# Rhode Island Airport Corporation

**ADDENDUM NO. 001**  
**Invitation for Bid No. 26298 – Sound Mitigation Program – Phase 4**  
**Group C**  
**T. F. Green Airport**  
**Warwick, Rhode Island**

Prospective Bidders and all concerned are hereby notified of the following changes in the Request for Bids document for the Sound Mitigation Program Phase 4 – Group C, at T. F. Green Airport, IFB No. 26298. These changes shall be incorporated in and shall become an integral part of the contract documents.

Sheet Title:  
HVAC PLAN  
BUILDING A  
LOWER LEVEL

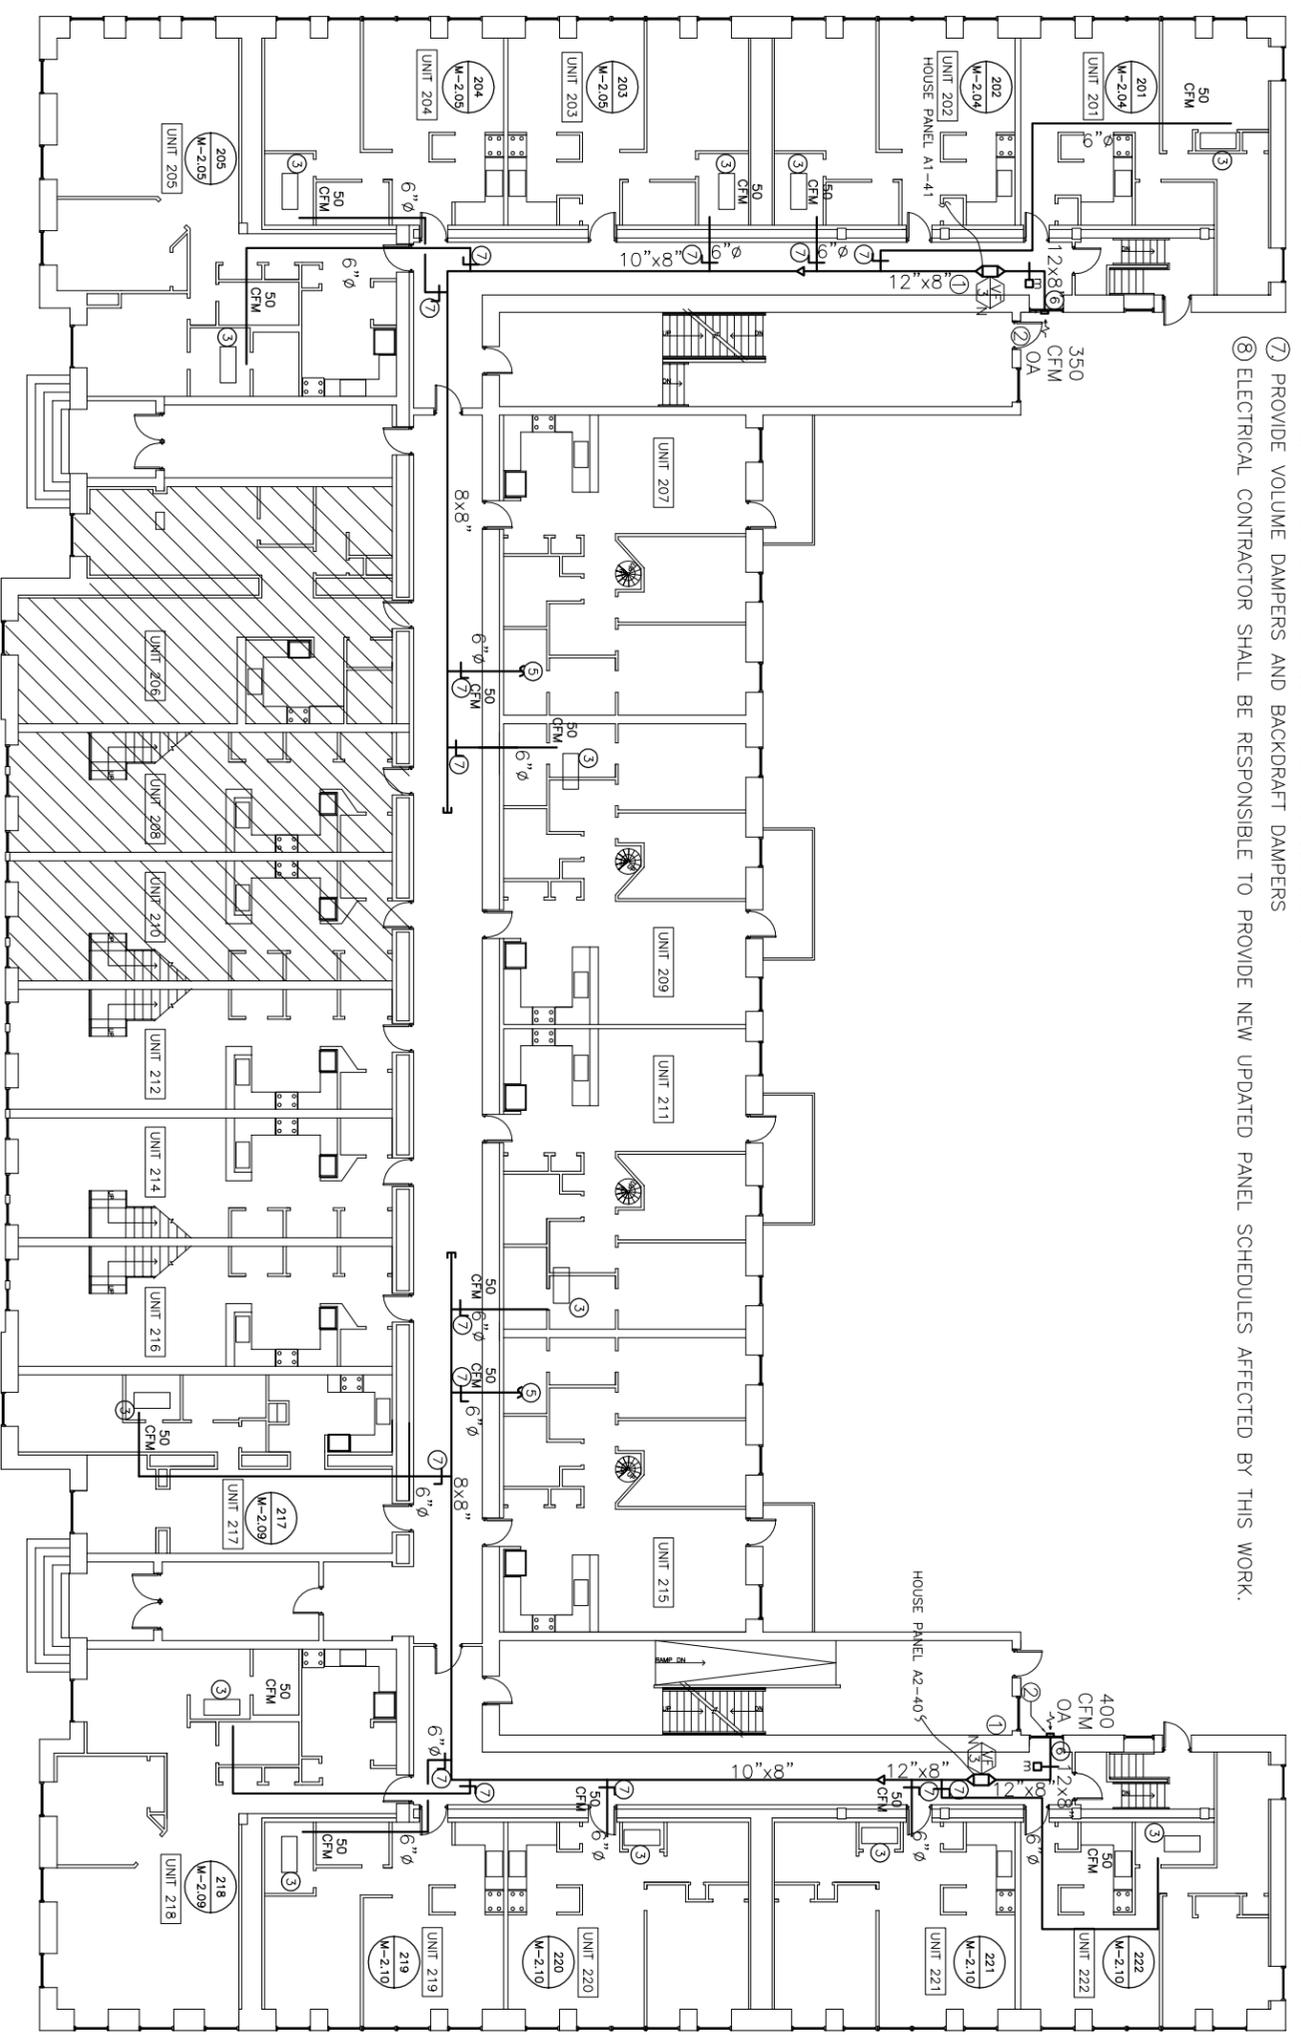
3. D2 HVAC DETAILS
  - Revised Detail 1 – Ventilator Fan Installation Detail (Lower Level)
4. M-1.01 (Bldg. A- Lower Level)
  - Added Electrical notes
  - Updated HVAC and Electrical Notes

- Revised duct sizes, and added temperature sensor and controller, backdraft damper
5. M1.02 (Bldg. A- First Floor Level)
  - Added Electrical notes
  - Updated HVAC and Electrical Notes

- ① NEW VF-3'S SHALL BE PROVIDED WITH MOTORIZED DAMPER, DISCONNECT SAFETY SWITCH, OUTDOOR TEMPERATURE SENSORS AND CONTROLLERS.
- ② 18"x18" EXTERIOR LOUVER BY GREENHECK MODEL ESD202 WITH BIRDSCREEN. (SEE DETAIL 4 OF SHEET D-3)
- ③ EXISTING AIR HANDLING UNITS LOCATED ABOVE CEILING.
- ④ CONNECT TO STAND ALONE CONTROLLER AND RELAYS LOCATED IN THE ELECTRICAL ROOM. CONTROLLERS SHALL BE LABELED FOR FAN DESIGNATION.
- ⑤ TO EXISTING AHU ON LOFT UNITS FOR VENTILATION.
- ⑥ ELECTRICAL CONTRACTOR SHALL DISCONNECT AND RECONNECT LIGHT FIXTURES, EXIT SIGNS AND FIRE ALARM DEVICES IN CORRIDOR TO GAIN EASY ACCESS FOR THE INSTALLATION OF HVAC EQUIPMENTS AND DUCTWORK.
- ⑦ PROVIDE VOLUME DAMPERS AND BACKDRAFT DAMPERS
- ⑧ ELECTRICAL CONTRACTOR SHALL BE RESPONSIBLE TO PROVIDE NEW UPDATED PANEL SCHEDULES AFFECTED BY THIS WORK.

Sheet Title:  
HVAC PLAN  
BUILDING A  
FIRST FLOOR

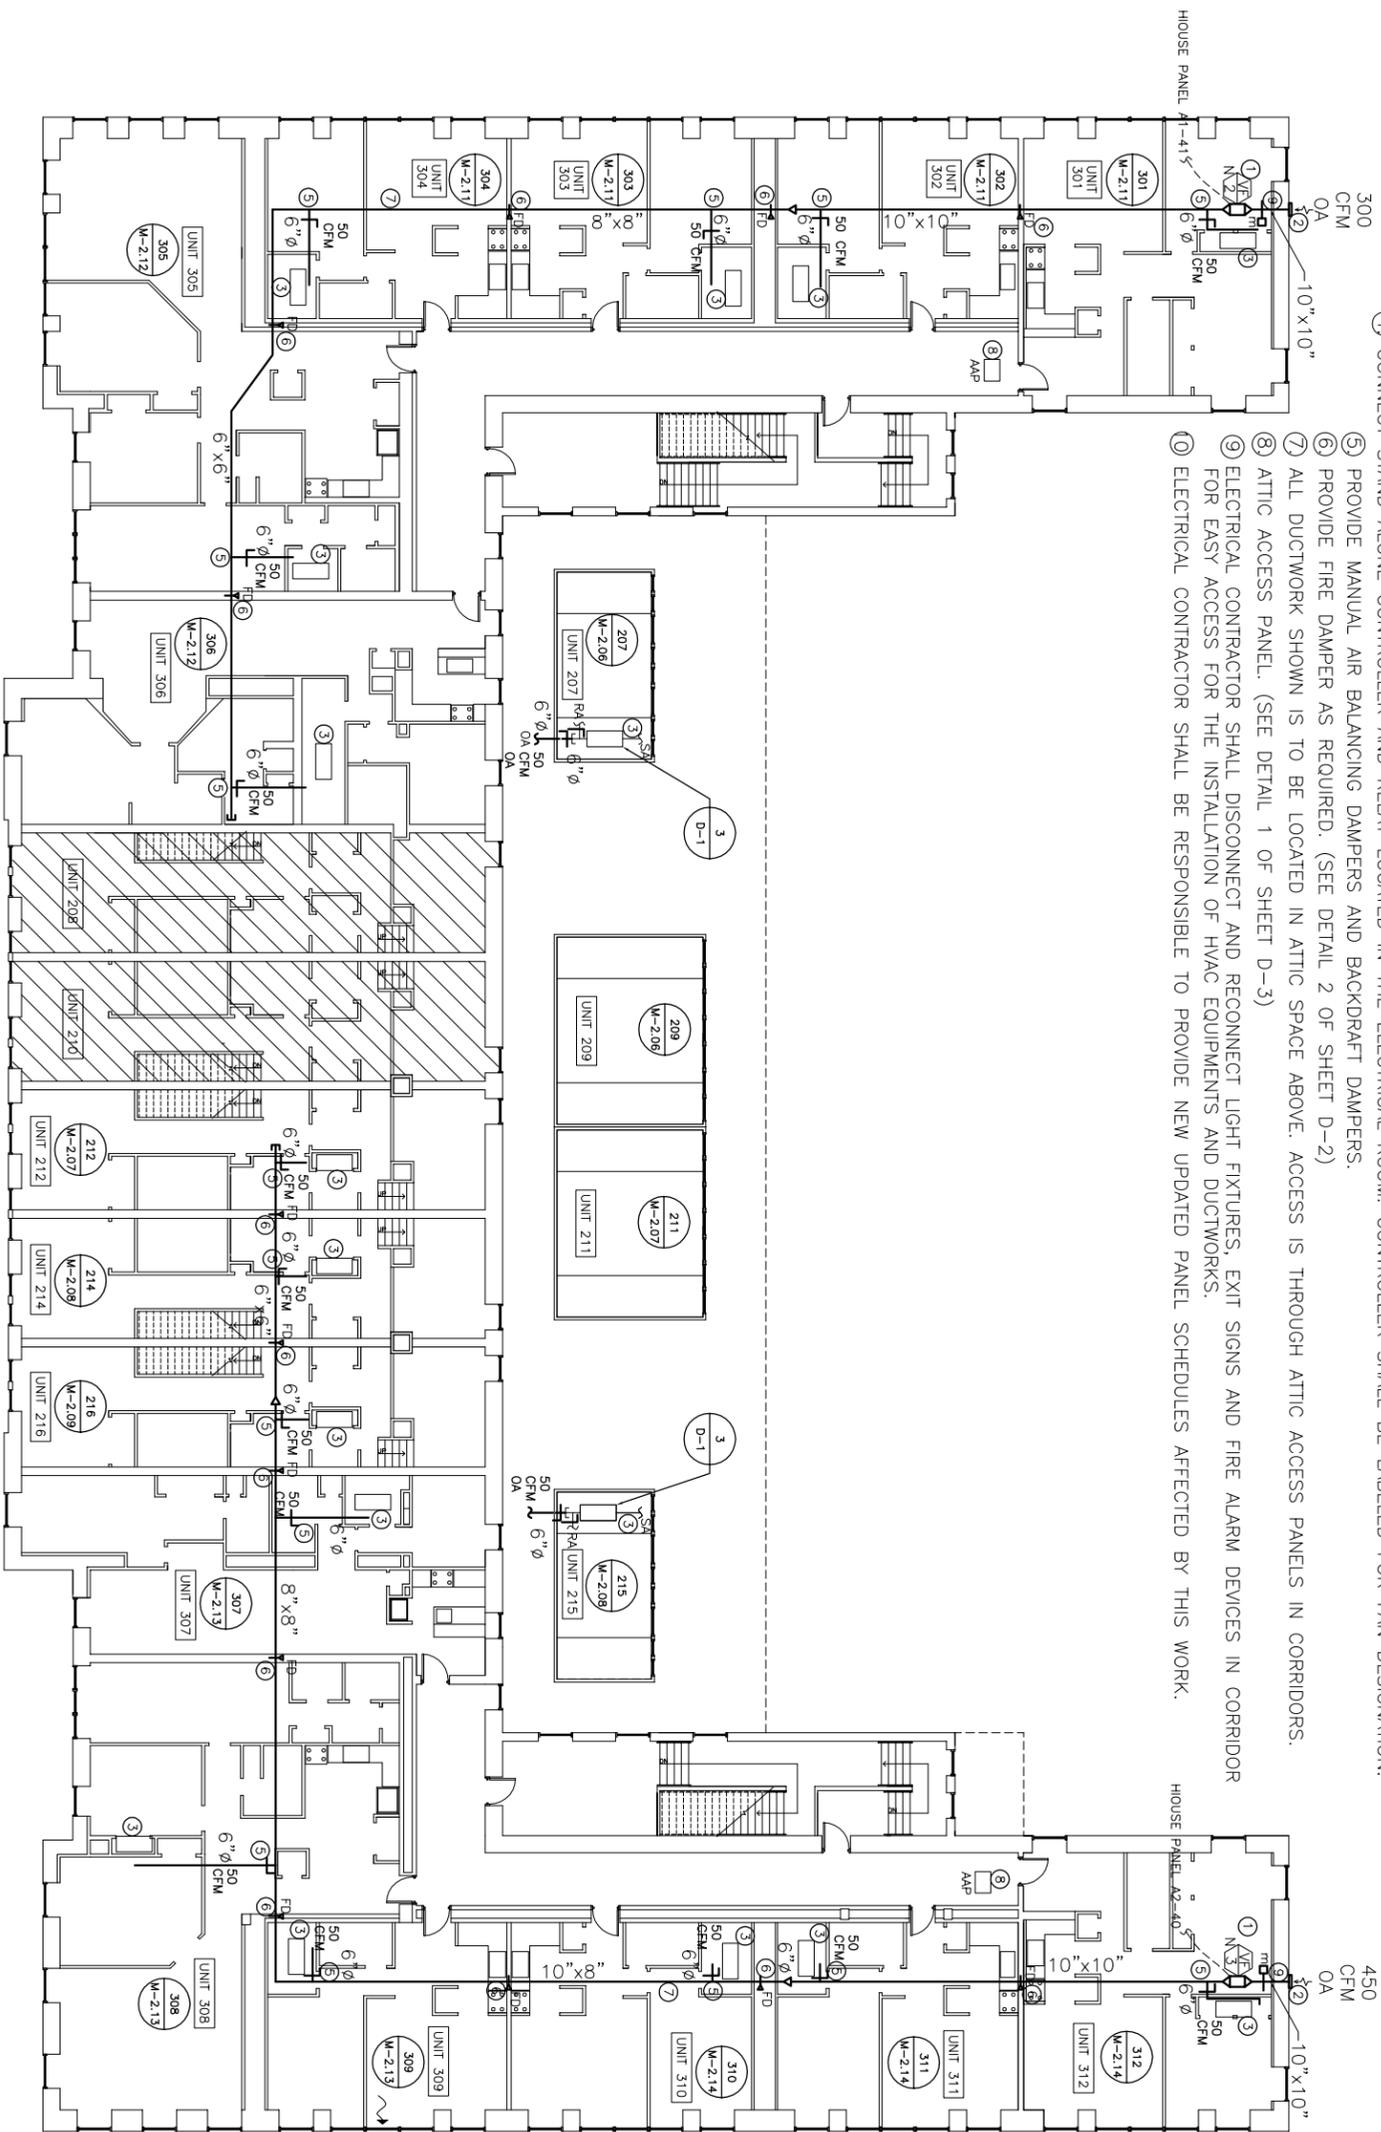
- Added temperature sensor and controller, backdraft damper
  - Revised fan size, and duct sizes for the additional ventilation for Loft units.
6. M1.03 (Bldg. A- Second Floor Level)

**M1.05**

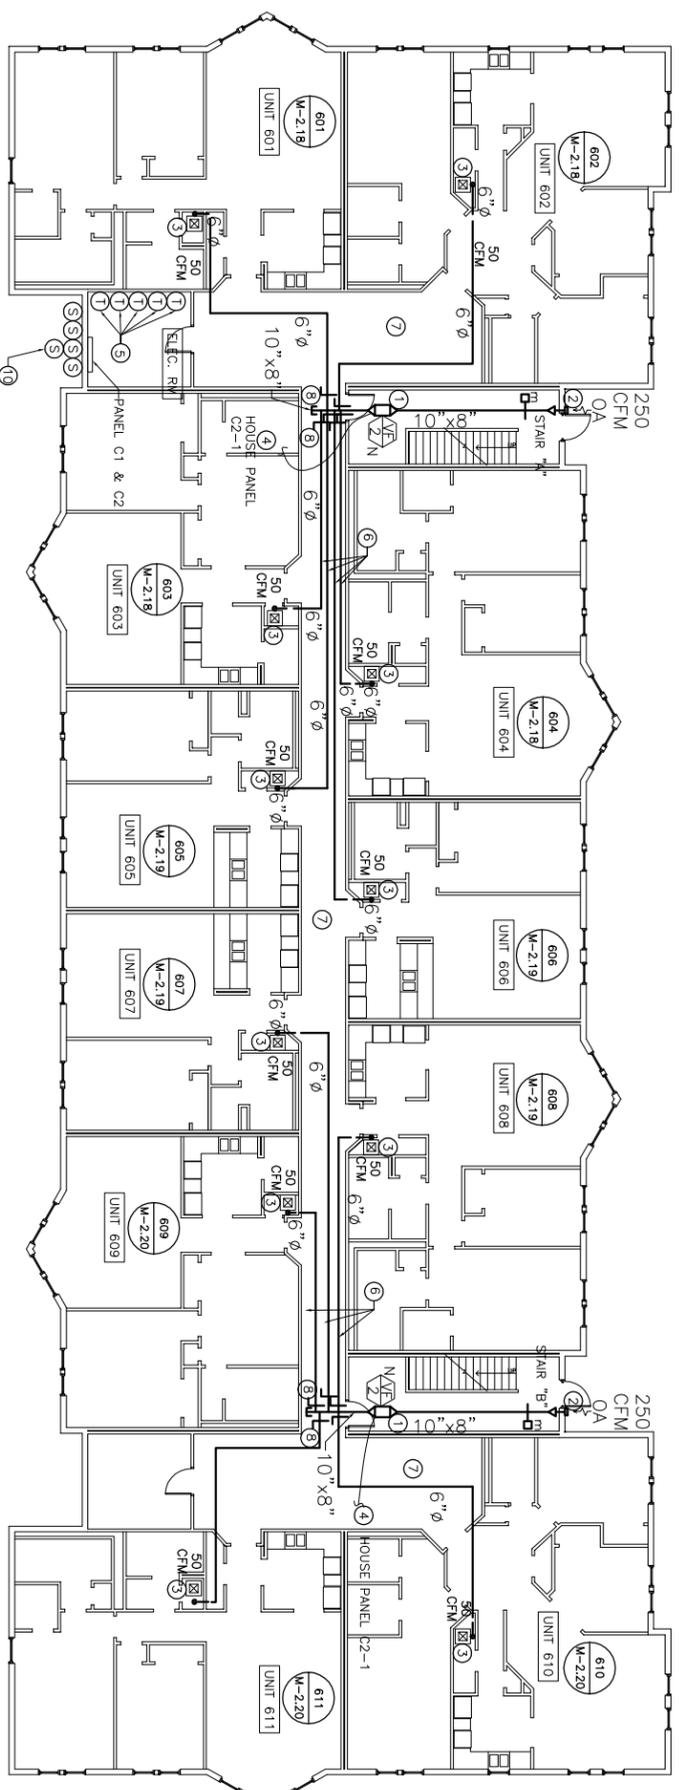
- Added temperature sensor and controller, backdraft damper
8. M1.05 (Bldg. B- Second Floor)
    - Added Electrical notes
    - Updated HVAC and Electrical Notes

- Added temperature sensor and controller, backdraft damper
    - Relocated (2)fans from corridor ceiling to stairway ceiling (due to lowering of ceiling)

**M1.07**

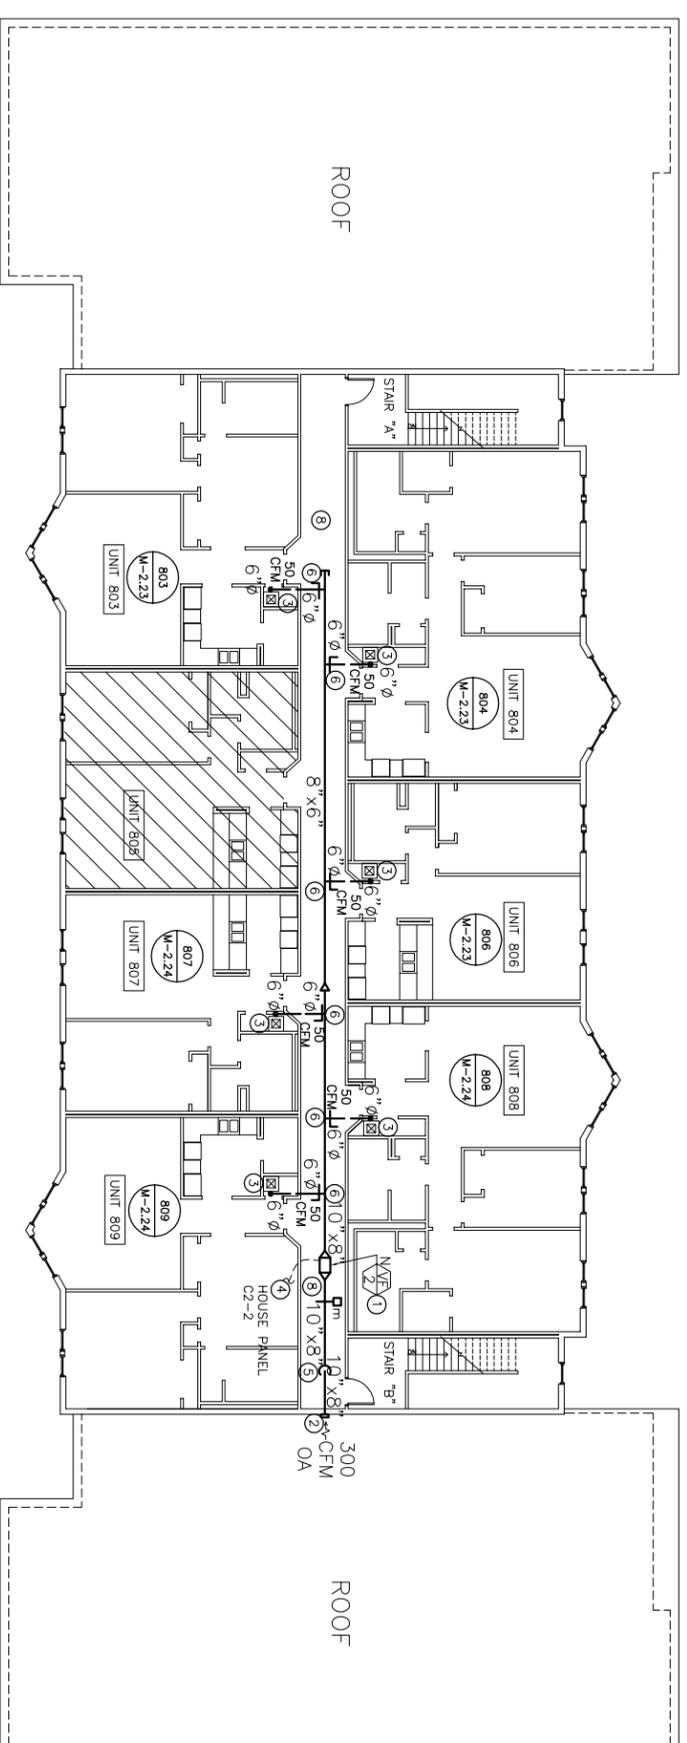
- Redone duct layout to fit HVAC equipments and ductwork
  10. M1.07 (Bldg. C- Second Floor)
    - Added Electrical notes
    - Updated HVAC and Electrical Notes

- Added temperature sensor and controller, backdraft damper
    - Redone duct layout to fit ventilator fans and ductwork
    - Relocated Ventilator fans

M-1.10

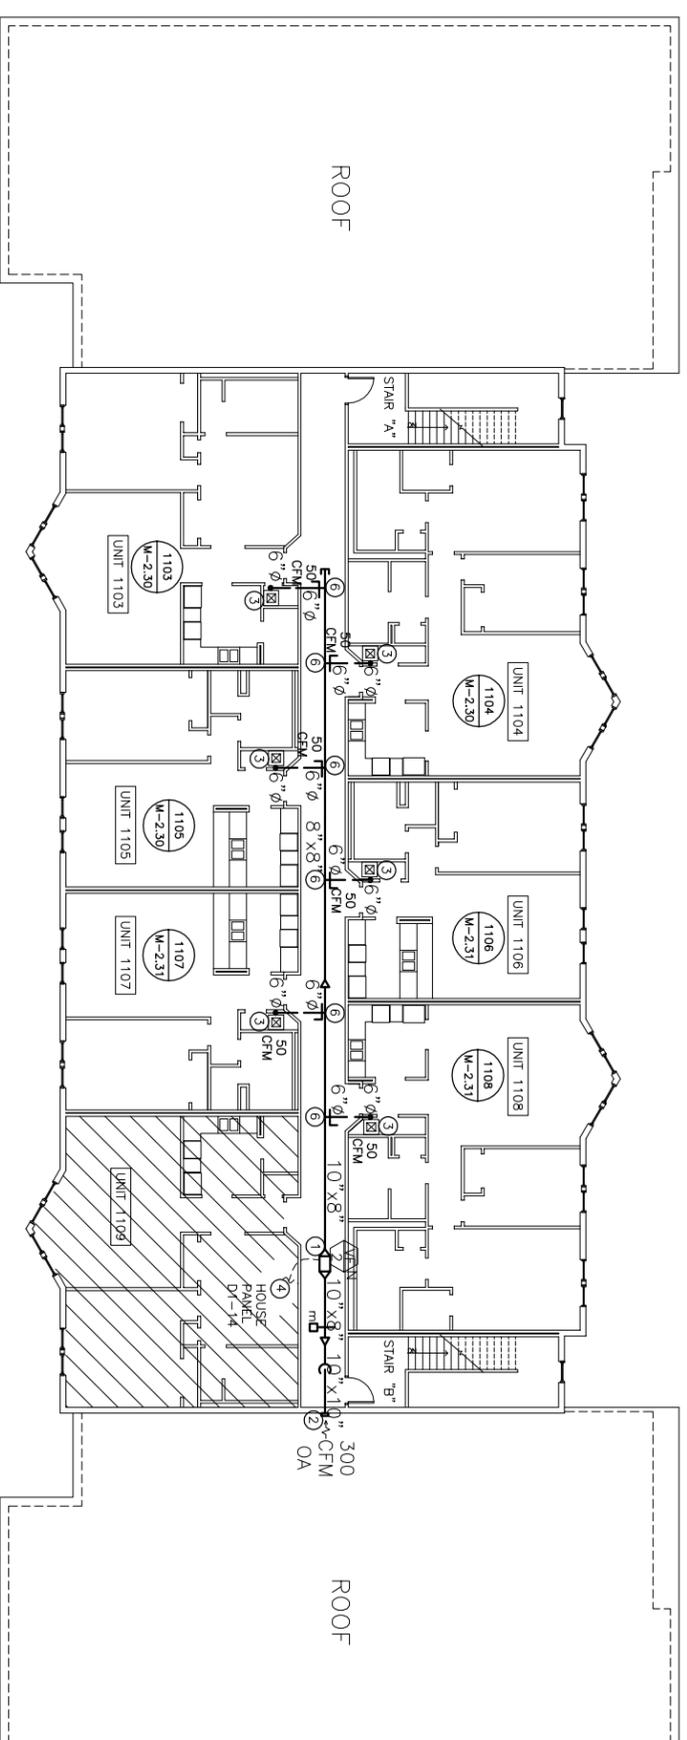
- Redone duct layout to fit HVAC equipments and ductwork
  13. M1.10 (Bldg. C- Second Floor)
    - Added Electrical notes
    - Updated HVAC and Electrical Notes

- Added temperature sensor and controller, backdraft damper
    - Redone duct layout to fit ventilator fans and ductwork
    - Relocated Ventilator fans
